NOTICE OF DECISION

ADMINISTRATIVE SITE DEVELOPMENT PERMIT AND ADMINISTRATIVE ADJUSTMENTS OF STANDARDS Solway Townhomes

APPLICATION NO: ASDP16-00003, AAS16-00013 and AAS16-00014

July 21, 2016

DRAWING
P3.00

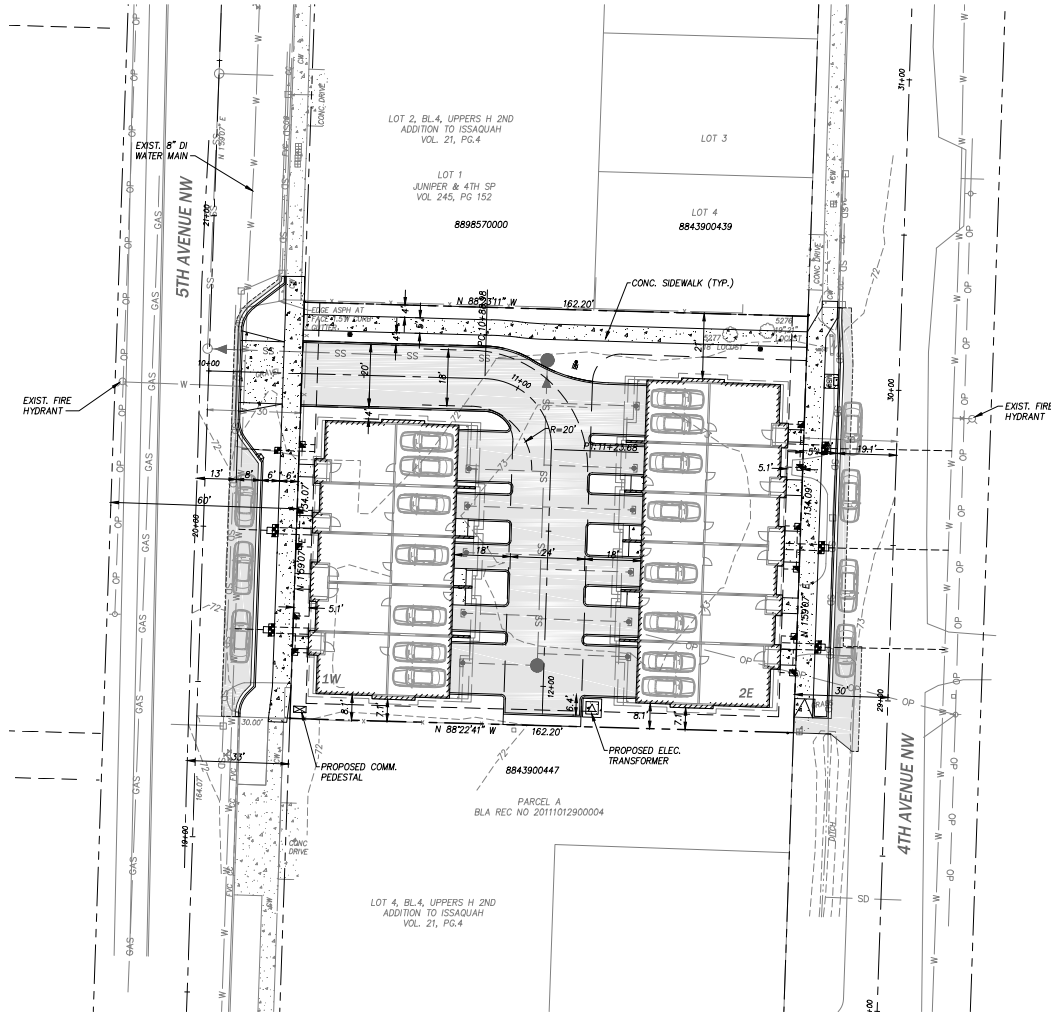
4. Irrigation meter called out on Sheet P3.00 but not shown on drawing. Show relocated irrigation water meter and provide detail of backflow prevention device installation. Reference Standard Detail W-16.
